Our Ref: 16283

8 August 2018

RE: TRESILLIAN FAMILTY CARE FACILITY, 25 SHIRLEY ROAD, WOLLSTONECRAFT DA 326/17 – TRAFFIC ADDENDUM

Figure 1: Proposed Layout Plan

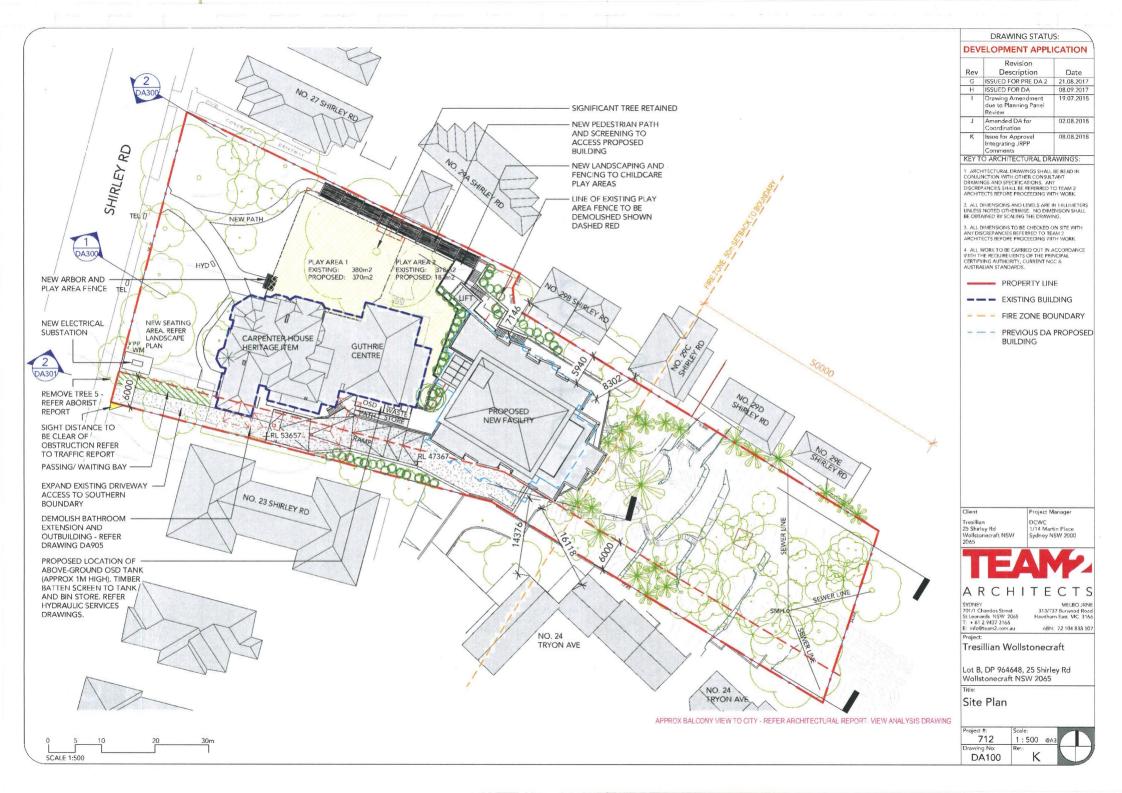
The proposed changes to the design include the extension of the ramp to accommodate appropriate vehicle access to the basement car park as a result of the reduced levels, i.e. from RL 49.9 to RL 47.37 in the basement car park. In addition to this, one (1) additional car parking space has been provided compared to the initial proposed development scheme (11 spaces) to allow for 12 spaces in total.

These car parking spaces have been designed as Class 3 parking facilities, with a minimum 2.6m wide by 5.4m long parking space and an aisle width of 5.8m as per AS2890.1:2004 design requirements.

Due to the changes in the levels as requested by the Panel, the ramp associated with the car park has been designed with a maximum grade of 25% (1 in 4) with the appropriate grade transitions in accordance with AS2890.1:2004. This is considered acceptable given that the car park will essentially be managed by Tresillian and operate as a private car park.

In addition to this, as per the previous proposal, the location of the existing building provides a pinch point between the access and the car park. It is the intention to manage the traffic flow past this pinch point by means of a traffic management system using lights to manage priority.
